ADDENDUM NUMBER TWO

**CHHS SCIENCE LAB RENOVATION
HAYWOOD COUNTY SCHOOLS**

MLA PROJECT NUMBER: 19017

DATE OF ISSUE: January 24, 2020

A201

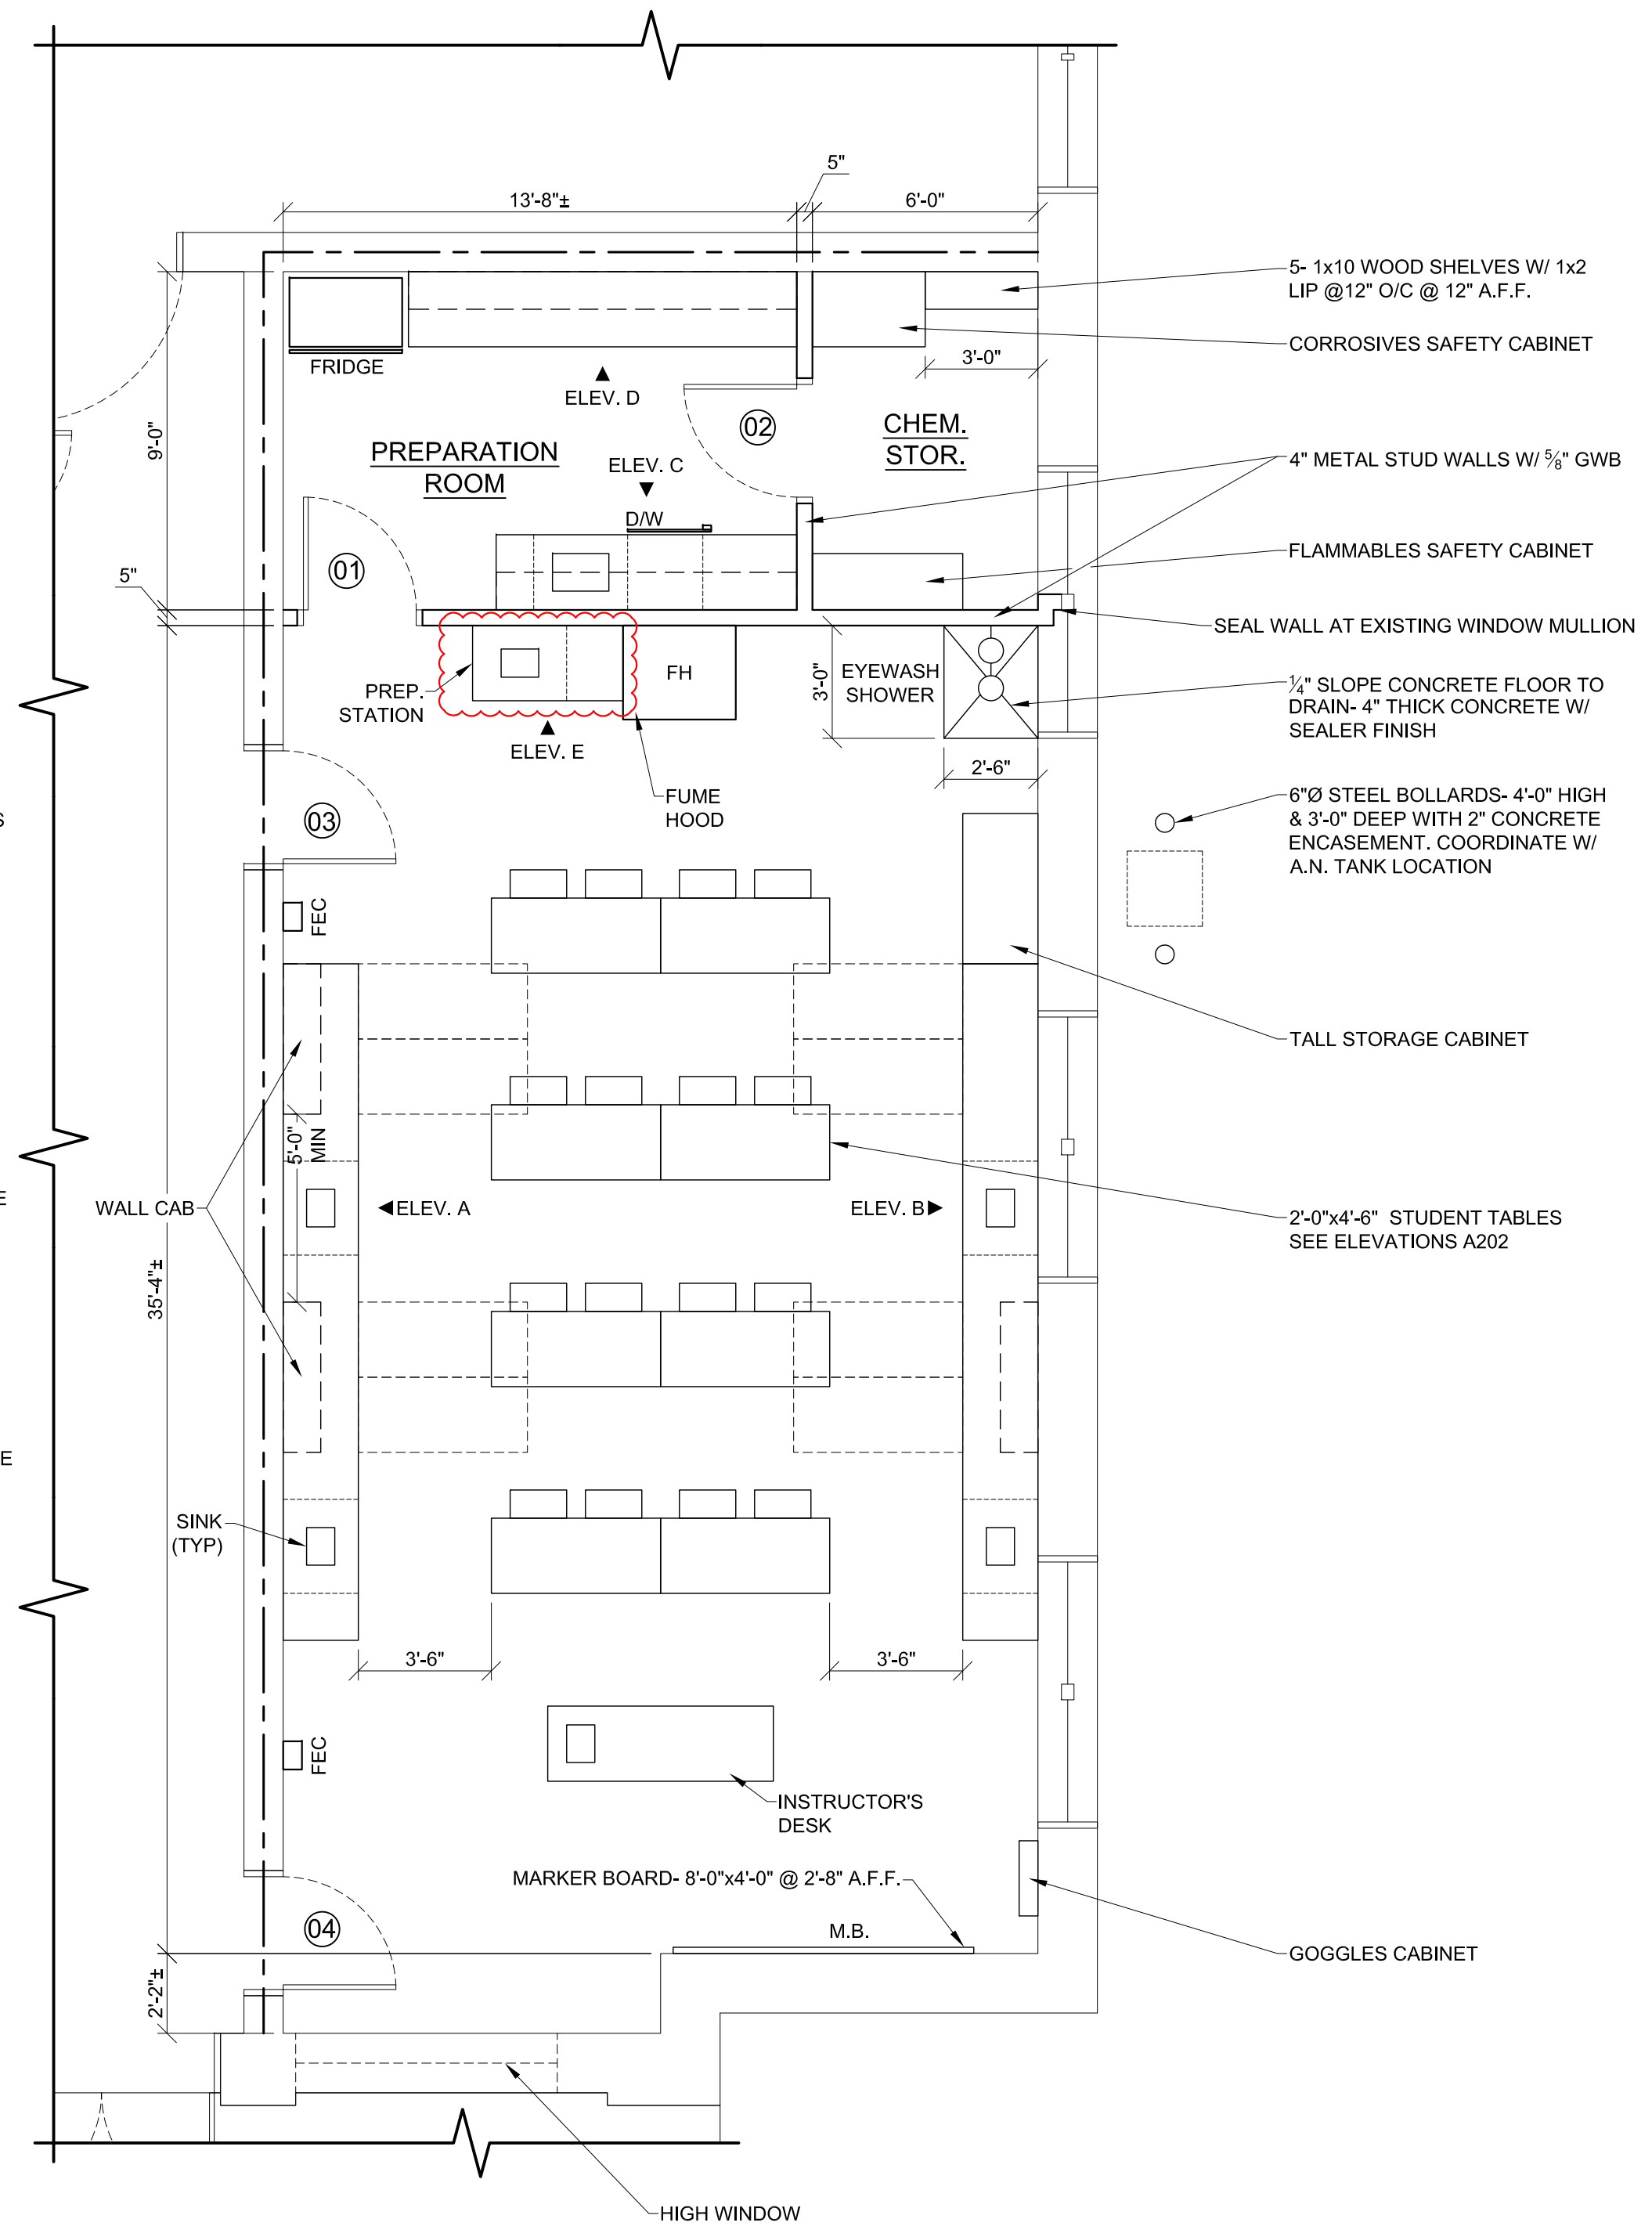
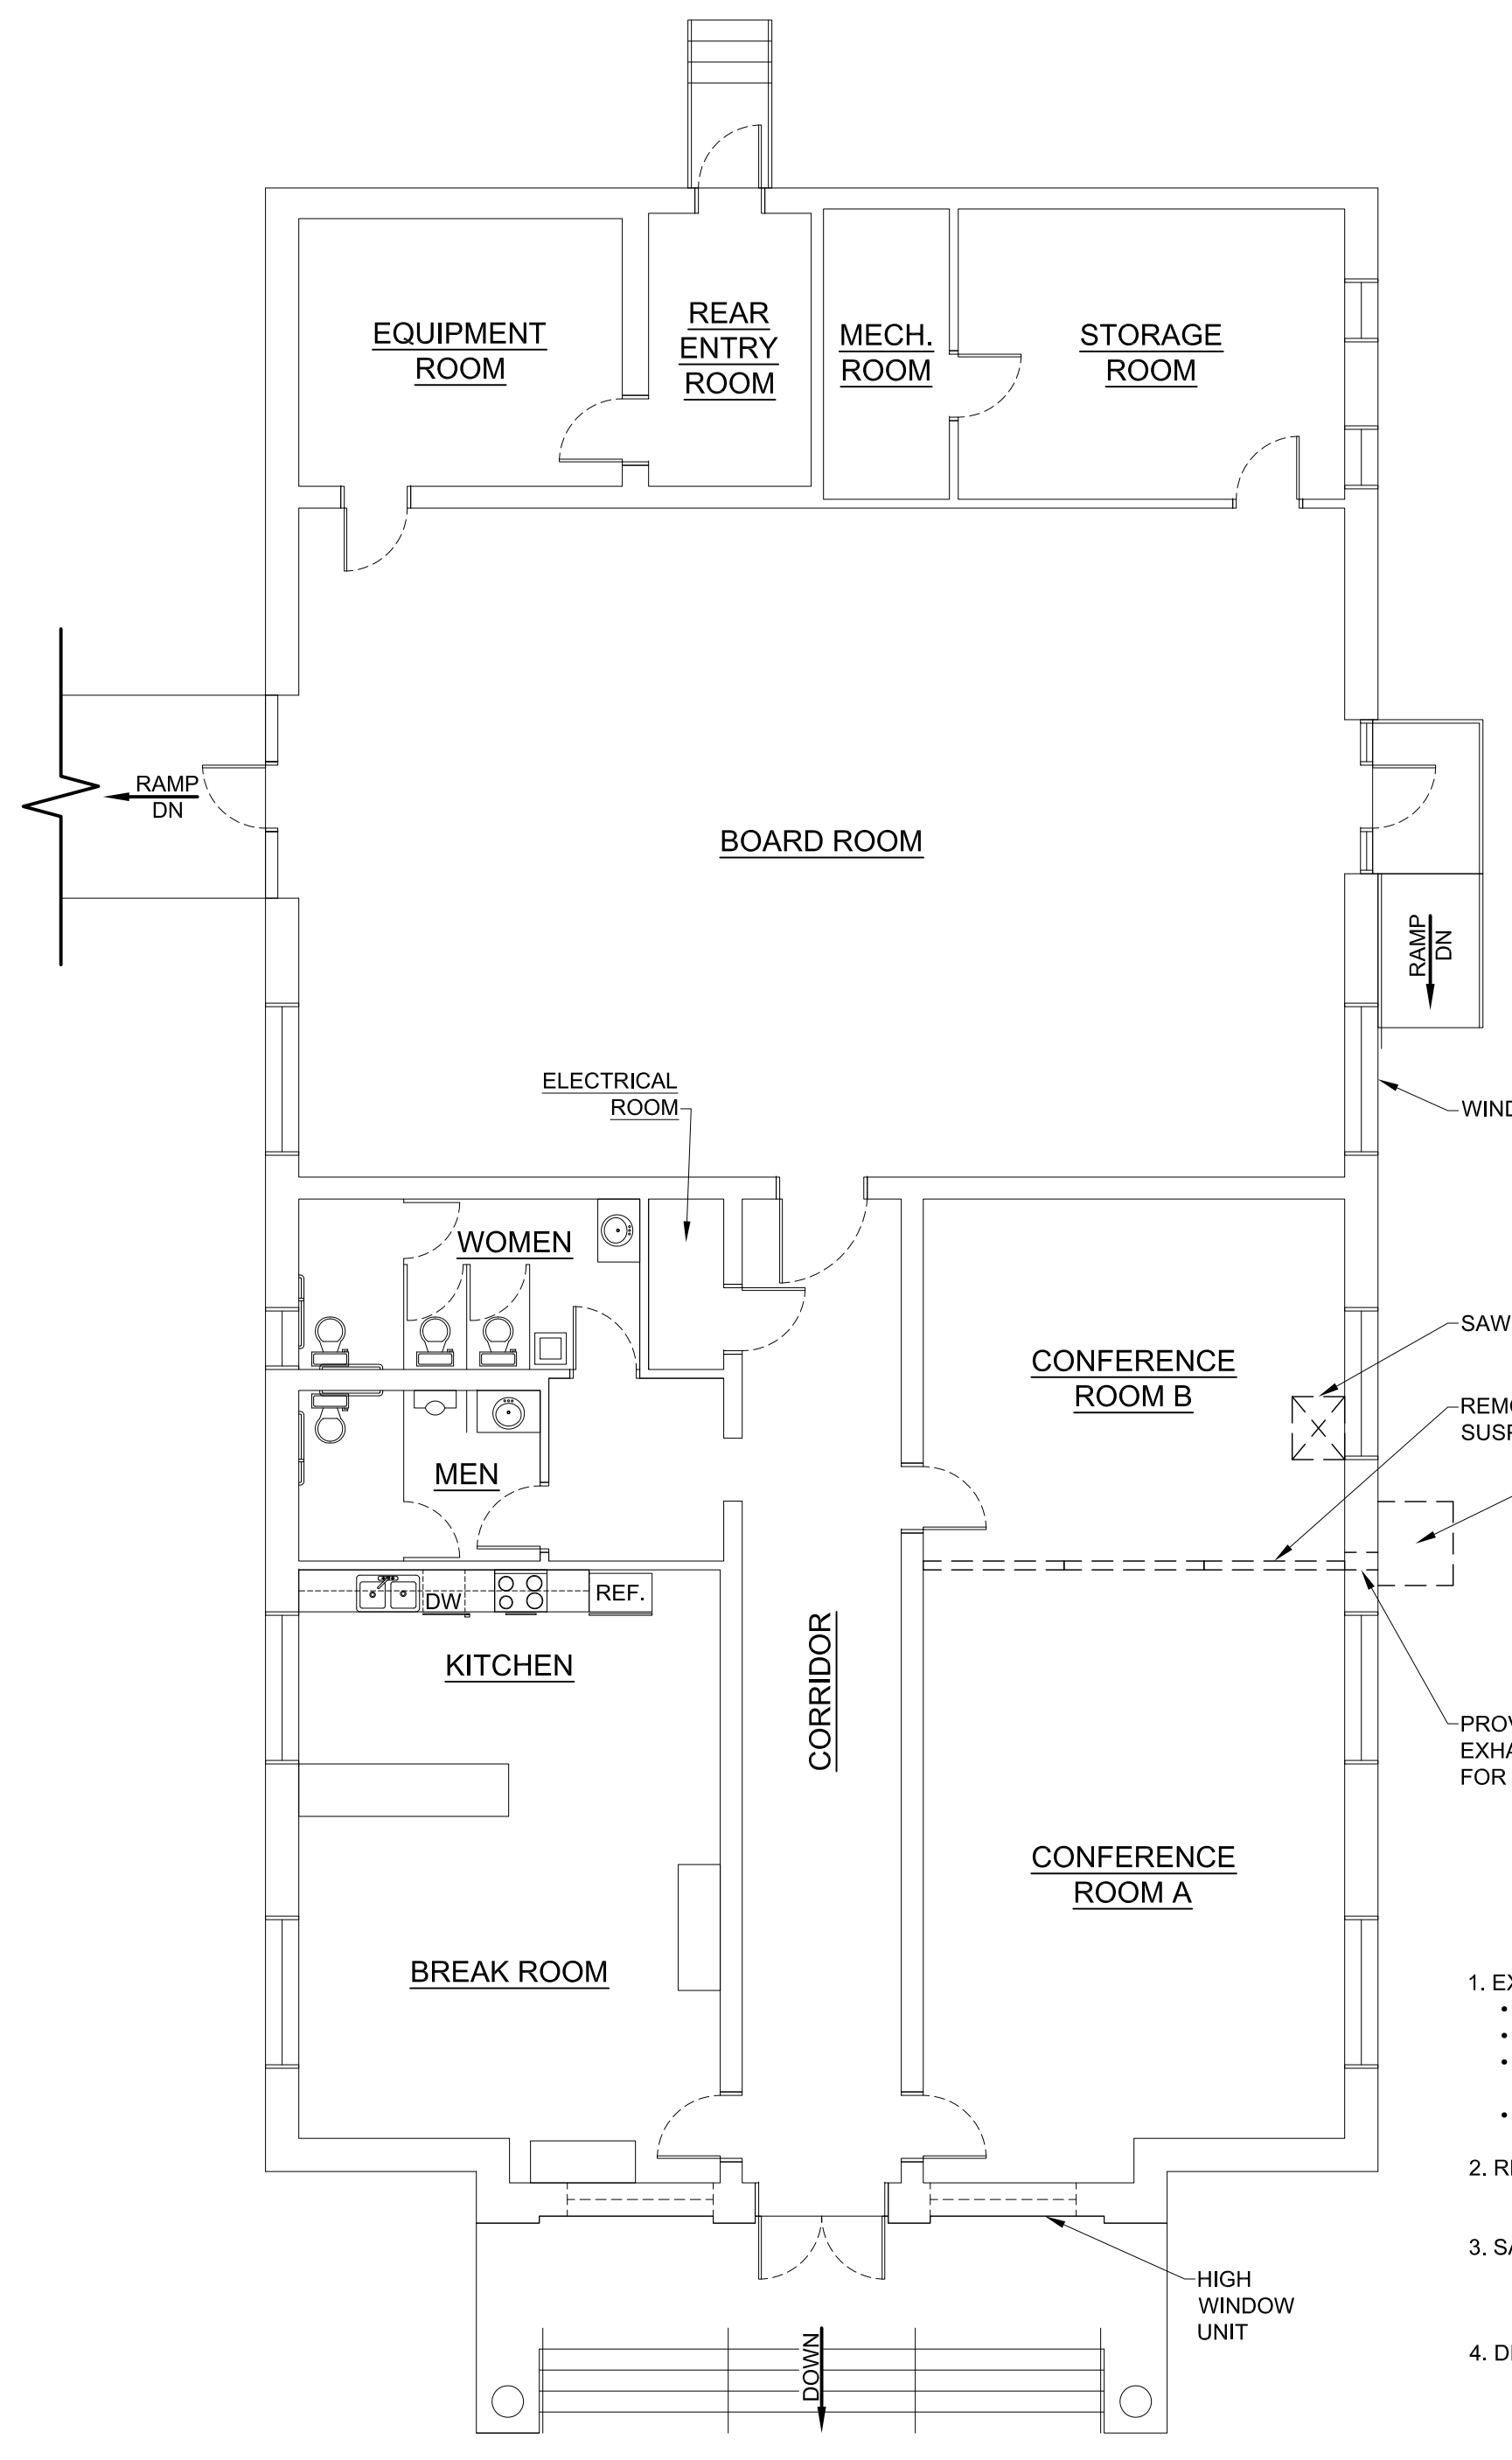
1. A201 - Owner provided casework. The contractor shall provide (furnish/install) fixtures along with supply and waste lines

1. See E1, E2, E3, P3 for :
 - a. Sheets E1 and E3. The legend and fixture schedule were revised
 - b. Sheet E3. A weatherproof GFCI receptacle was added for the water heater Emergency Shut Off switch
 - c. Sheet E3. A GFCI receptacle was provided for maintenance at exhaust fan in the attic
 - d. Sheet E3. All GFCI receptacles were labeled
 - e. Sheet P3. Water supply lines added.
2. See A201 for revision to casework and Alternate
